APPEAL SUMMARY

Appeal ID: 31480	Project Address: 3933 NE MLK Jr Blvd
Hearing Date: 4/12/23	Appellant Name: Dennis Hadley
Case No.: B-017	Appellant Phone: 503-422-6235
Appeal Type: Building	Plans Examiner/Inspector: David Bartley
Project Type: commercial	Stories: 2 Occupancy: R-2, R-3, B Construction Type: V-B
Building/Business Name:	Fire Sprinklers: Yes - throughout
Appeal Involves: other: Fire separation requirement	LUR or Permit Application No.: 22-121830-CO
Plan Submitted Option: pdf [File 1] [File 2]	Proposed use: Adult Care Facility

APPEAL INFORMATION SHEET

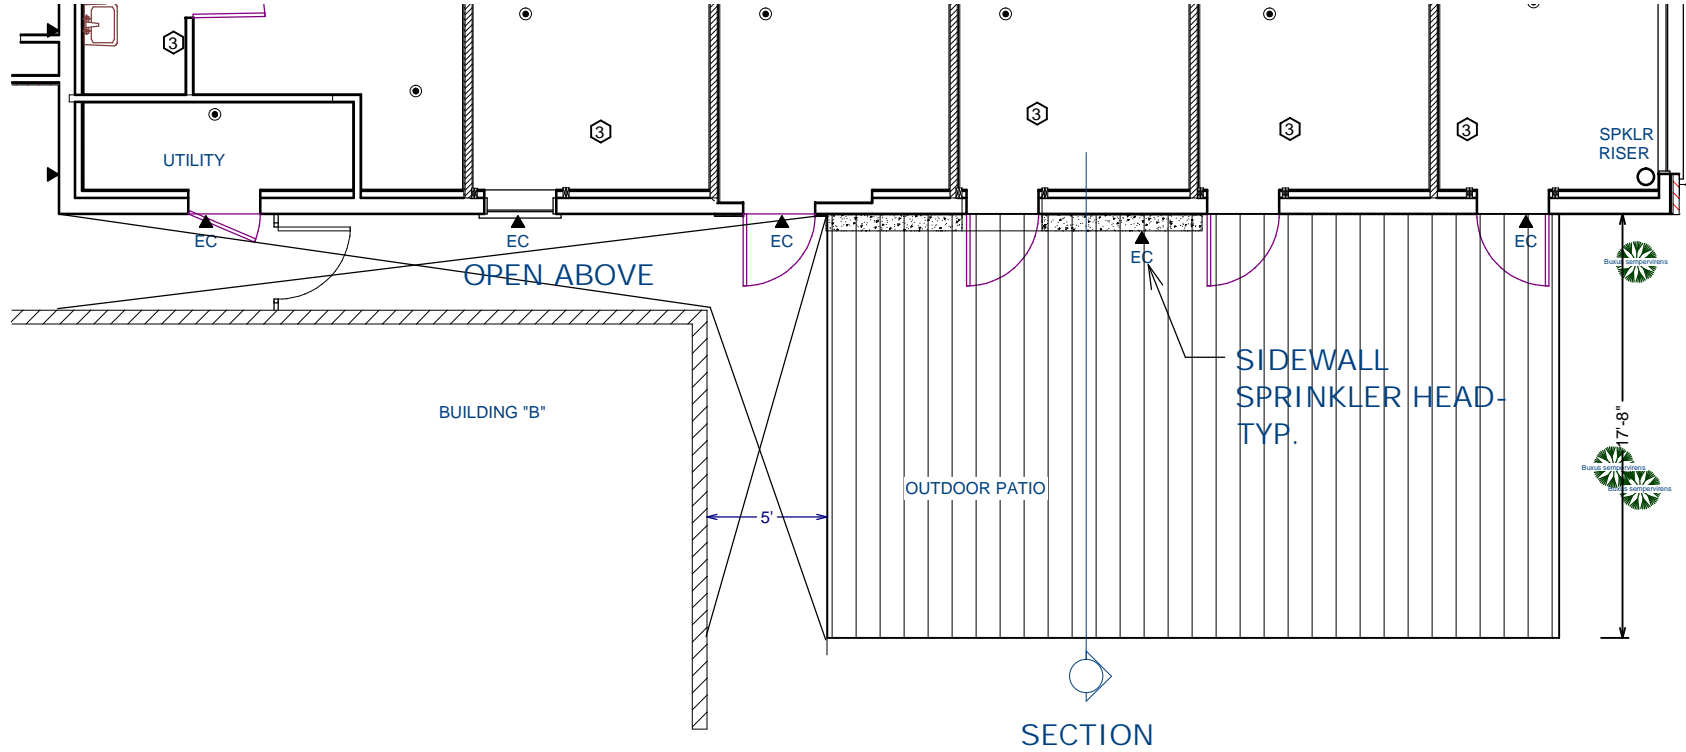
I looked up the model number. This head is a "dry" sidewall, Which is appropriate for this application.

It is not an extended coverage (EC) as they are calling out in the appeal.

The area that they are trying to cover is 17' 8" in depth, and the installed heads are standard coverage (15'x15').

These sidewalls were not part of the approved FS permit. (21-070079)

- EC heads?
- Permitting for those heads (design)
- Workmanship-like install, the holes look like they are roughed in but not finished
- Use of the patio?

I would recommend holding for further or even denying this until the sprinkler system issues are fixed.

SECTION @ PATIO COVER

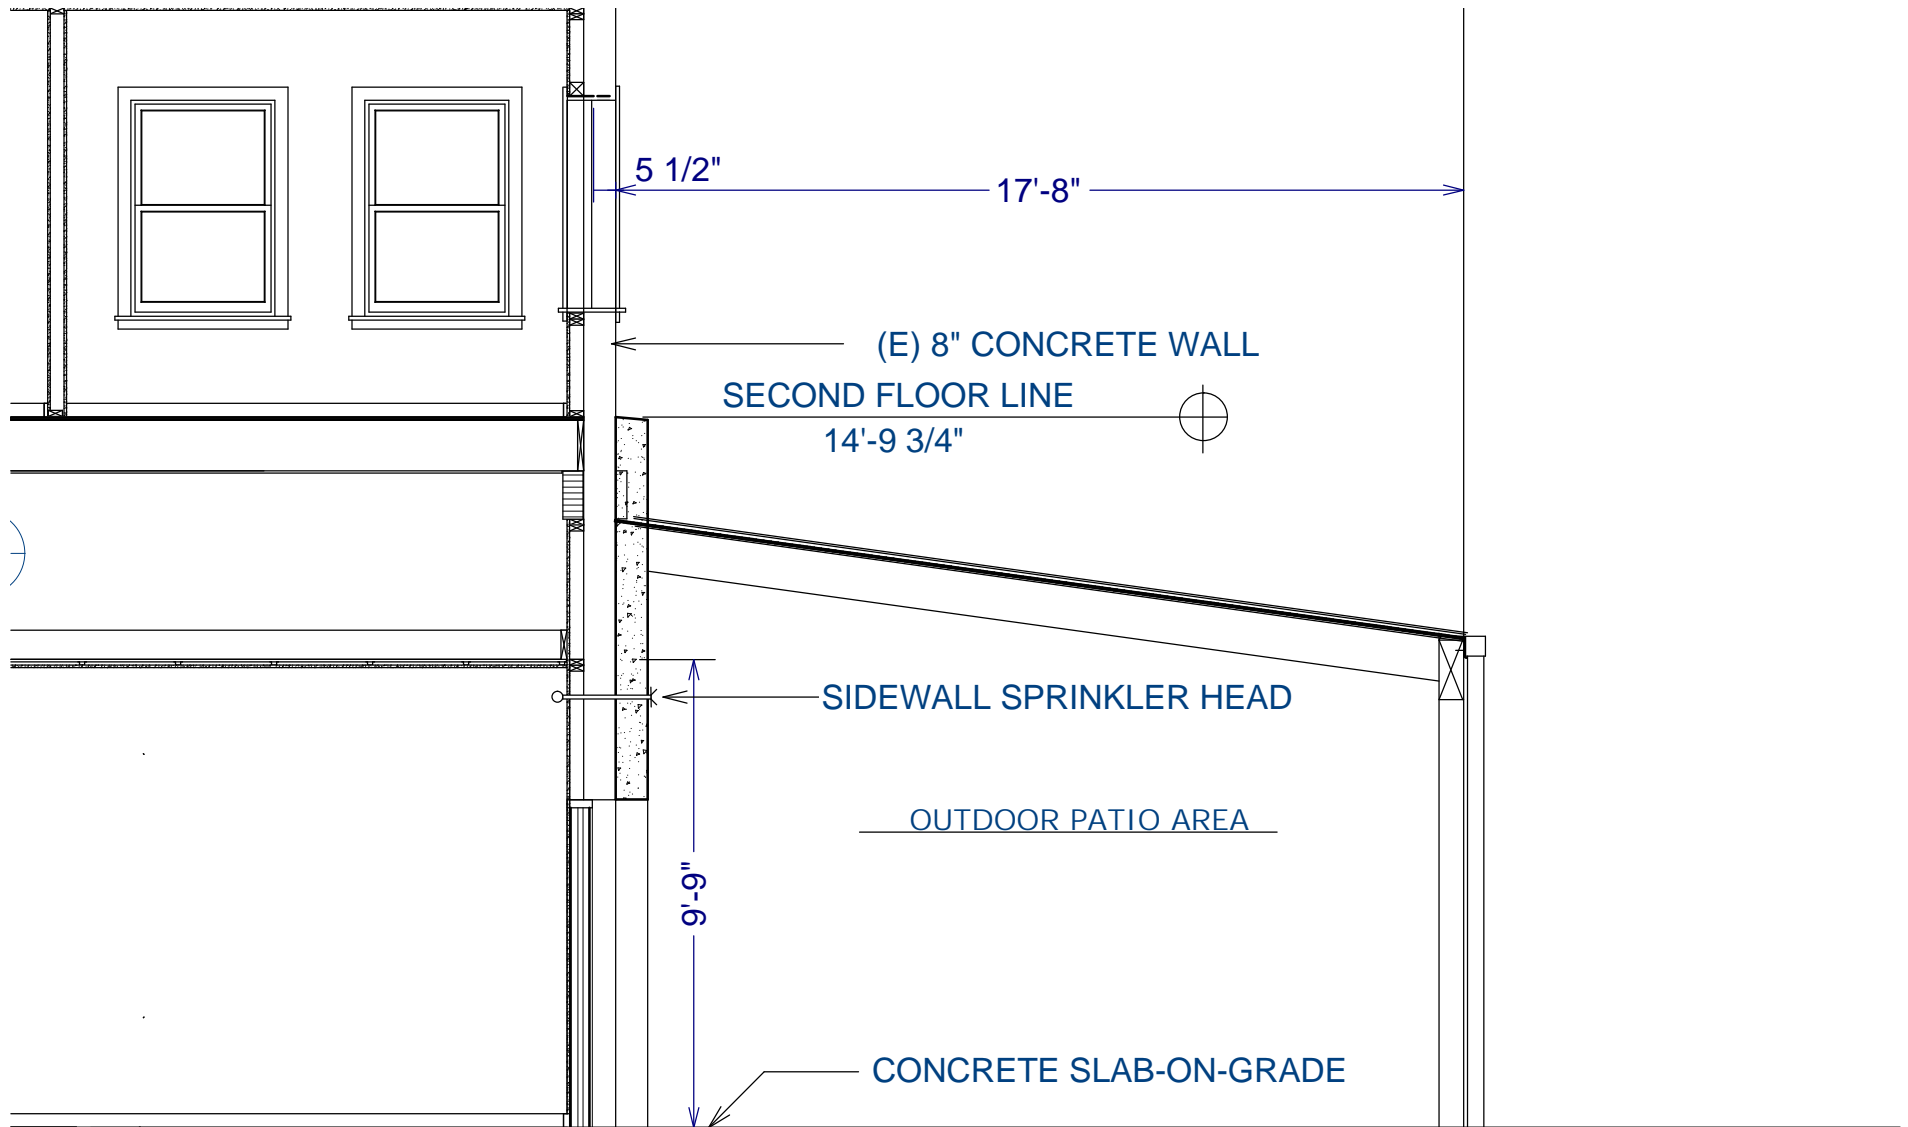
Correction: I said sprinklers above, but they're below the patio cover, and only at the building wall where the patio cover is attached.

This is a patio cover, so completely open underneath, just posts. The patio cover and the adjacent building are both V-B. The only added protection is sidewall sprinklers above the patio cover. Their main argument is "no one called us on it," but I called it at permit review, and the Architect changed the Architectural drawings to provide 20' separation.

Reduction in the minimum required fire separation distance from 20 feet to five feet: Denied. Proposal does not provide an equivalent level of Life Safety protection.
